SHENZHEN FENDA TECHNOLOGY CO., LTD.

Ref: FCC Class II Permissive change for FCC ID: HBOPA2323

This is to request a Class II Permissive change for FCC ID: HBOPA2323
originally granted on Dec 22, 2022.

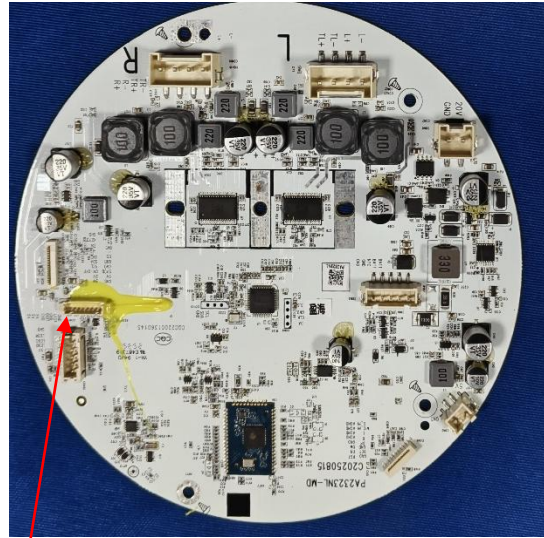
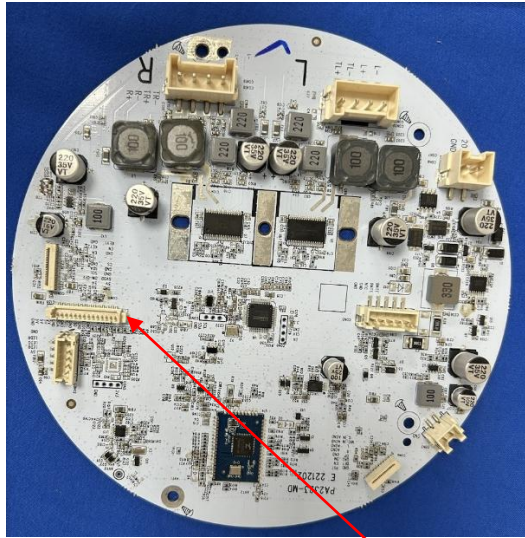
1. The motherboard has changed the interface socket for connecting the light board, and the light board has been changed from a single-sided board to a double-sided board.
2. The RGB light has been changed to a 4-pin RGB light with its own driver chip, and the original light driver chip has been removed.

Before change :

After the change:
